SESSOM CREEK IMPROVEMENTS PROJECT- PHASE 1

TO: Bert Lumbreras – City Manager
THRU: Laurie Moyer, P.E. - Director of Engineering and Capital Improvement
FROM: Shaun Condor, P.E. - Senior Project Engineer
DATE: March 22, 2018
RE: Loquat Closure Update

SUBJECT OF MEETING: Loquat Closure

Alternative 1 - T Intersection

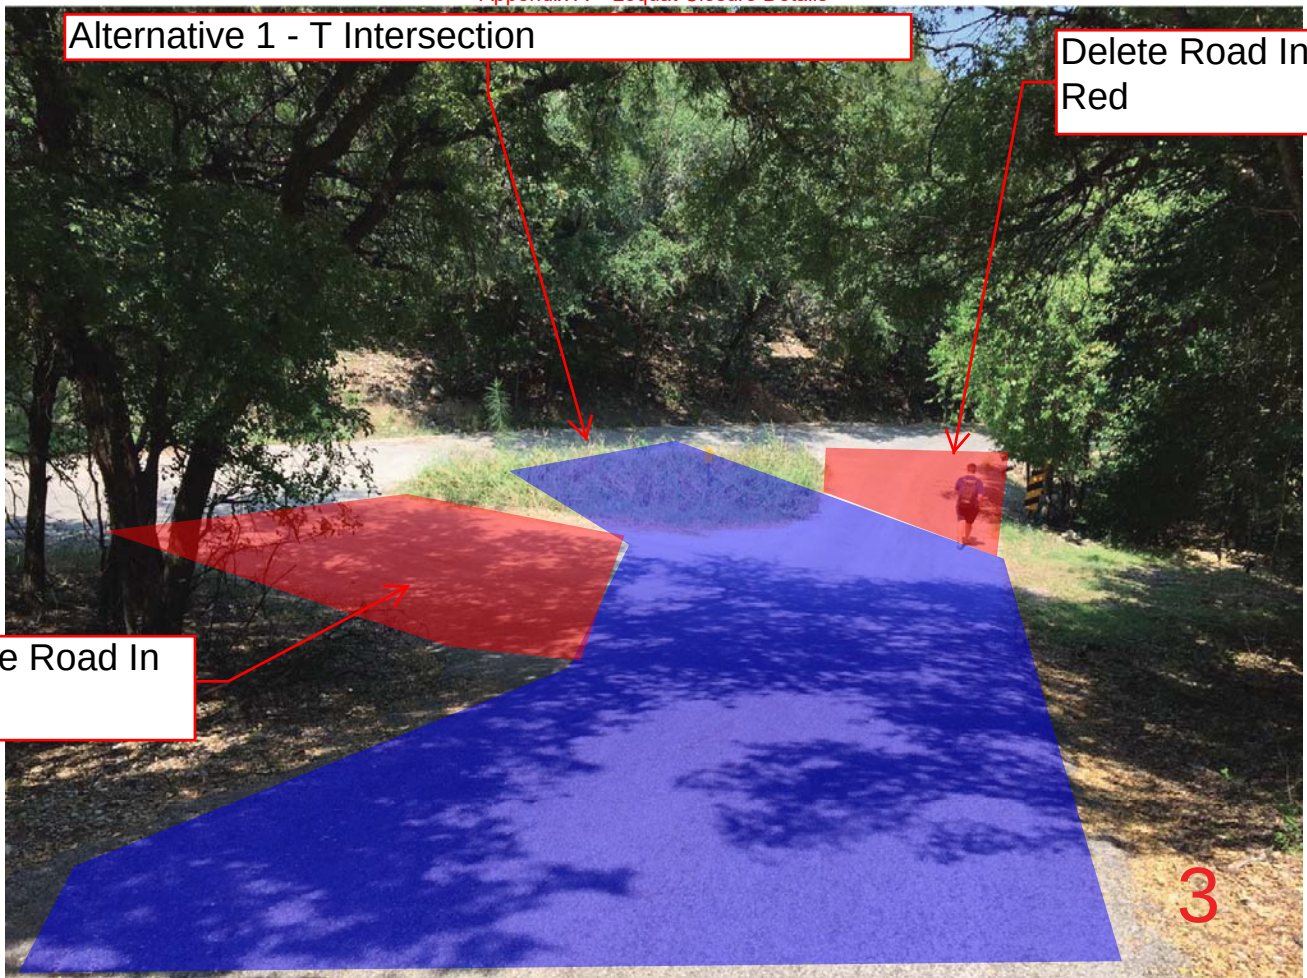
- a) **Fire** - below are our two main objections to closing Loquat. Preferred to keep the road open.
 - 1. Delayed response times (in and out). Responding units 1 3 4 and 5 would have to drive all the way around to Ridgeway to access Canyon Dr.

- 2. Safety - it's already tight on the roadway (Loquat and Canyon). If you remove the intersection. Units will have to back all the way up Canyon Dr. to exit. Not safe to do so. At least if the intersection stays we can back up Loquat to turn around.

- b) **Police** – No major concerns with either option. They prefer multiple routes; but they can adapt.
- c) **Development Services** – Prefer to keep it open; if closed, need to account for pedestrian route

- d) **Transportation** – No major concerns with either option.
- e) **Engineering** – Only major concern is loss of connectivity.
 - i) Cost should be about the same for both alternatives.

- o **Staff Response**
 - **Emergency Access** – we will use the cost savings from the stabilization work to build “Hammerheads” so large vehicles can safely turn around.

- **Response Time** – nothing can be done on this project; but we can add a CIP to extend Canyon Road to Chestnut to provide an alternate route in the future will could help reduce response time.

- **Pedestrian Access** – The San Marcos Greenbelt Alliance has committed to building and maintaining a hike and bike trail connecting Canyon Road to Loquat. The trail (non-ADA) will be a at grade crossing which will not be accessible during high rain events

Alternative 2: Delete Entire Road in Red

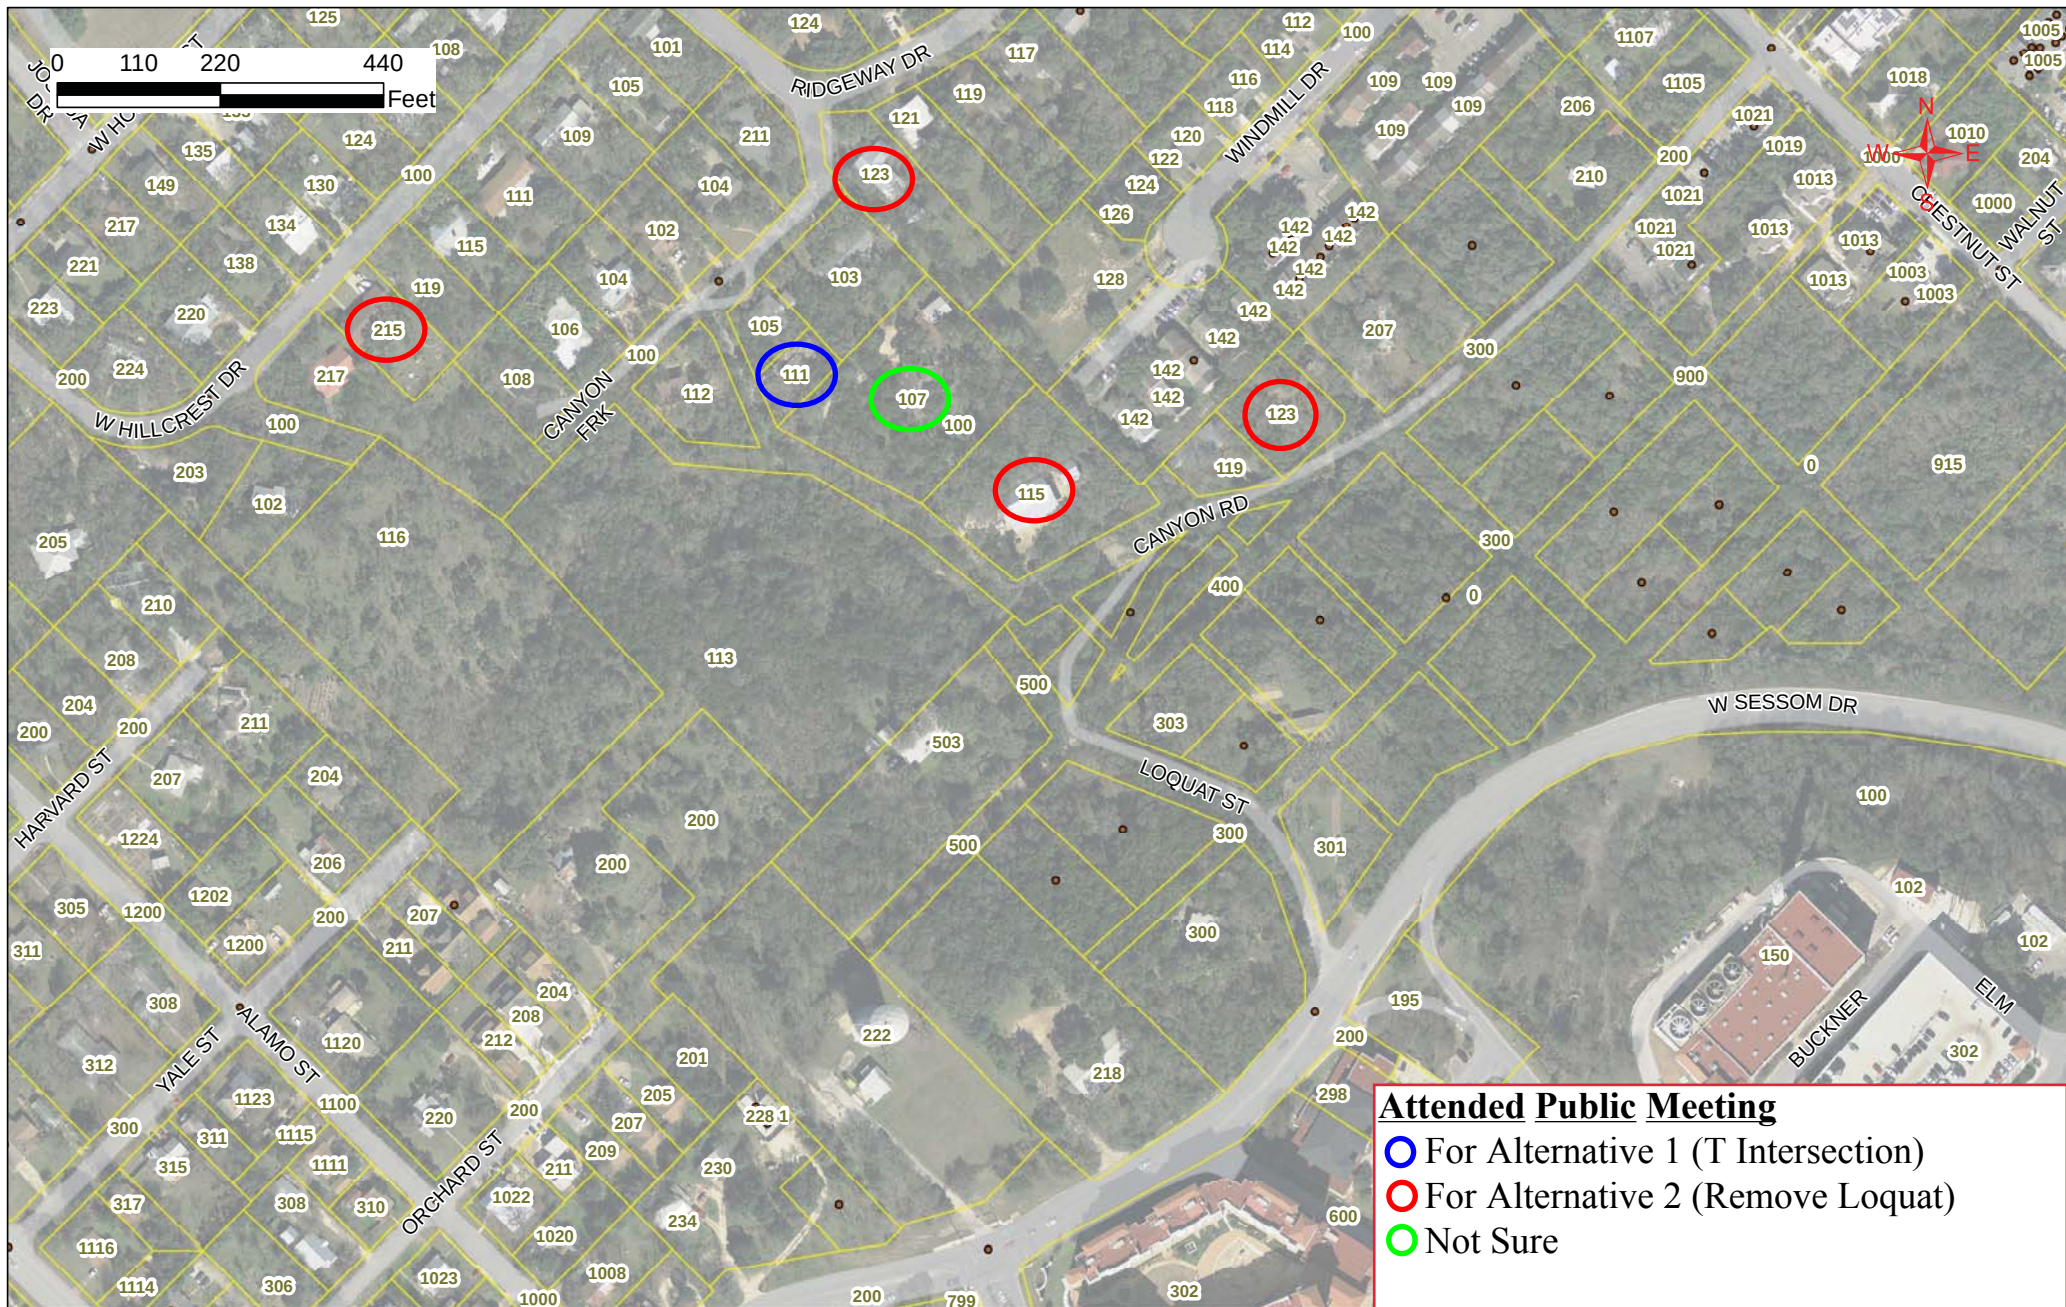
- o **Fire** - Below are our two main objections to closing Loquat. Preferred to keep the road open.
 - Delayed response times (in and out). Responding units 1 3 4 and 5 would have to drive all the way around to Ridgeway to access Canyon Dr.

- Safety - it's already tight on the roadway (Loquat and Canyon). If you remove the intersection. Units will have to back all the way up Canyon Dr. to exit. Not safe to do so. At least if the intersection says we can back up Loquat to turn around.
